## Response to Reviewers — SENSL-26-06-RL-0906

### “Wire-Level Interrupt-to-Decision Latency of On-Sensor MLC versus Host Inference on the NVIDIA Jetson Orin Nano: A Pre-Registered Measurement Study”

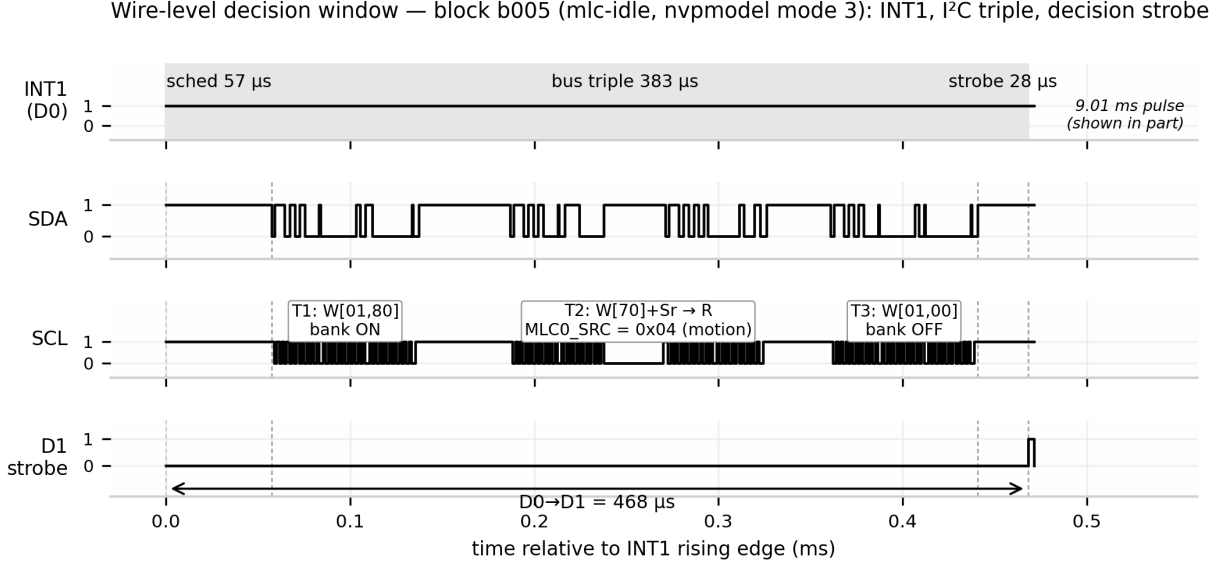
*“For a ‘wire-level’ study, the absence of logic-analyzer traces, or a timing diagram showing INT1/D1 edges and the three I<sup>2</sup>C transactions, is a glaring omission. A single figure would have added enormous credibility.”*

**Response:** We agree, and the omission is corrected with a measured SDA/SCL figure, not a schematic. The figure below is rendered by `code/analysis/fig_wire_timing.py` directly from the archived Saleae export for block b005 (mlc-idle, nvpmode mode 3) in the evidence package (Zenodo DOI 10.5281/zenodo.22950121). The four lanes are INT1 (D0), SDA, SCL, and the decision strobe D1. The decoder requires and finds exactly the four wire frames of the bank-switch read in the shown window: T1 W[01,80] (embedded-functions bank ON), T2 W[70] + repeated-start read of MLC0\_SRC (=0x04, motion), and T3 W[01,00] (bank OFF). For the shown window (t = 22.906 s): INT1→first-byte scheduling 57.4 μs, complete three-transaction triple 383.4 μs, last-STOP→D1 strobe 27.5 μs, D0→D1 468.3 μs, with no foreign frame inside the triple. Campaign statistics remain in Table I and S4; this figure is the wire-level existence proof for the protocol those statistics decompose.

**Manuscript changes:** §VI.A pointer sentence added; the measured capture is provided as Fig. S4 in the supplementary material and is embedded in this response, generated reproducibly by `code/analysis/fig_wire_timing.py` from the archived capture; the extended candidate-mechanism discussion remains in S3 to preserve the 4-page limit.
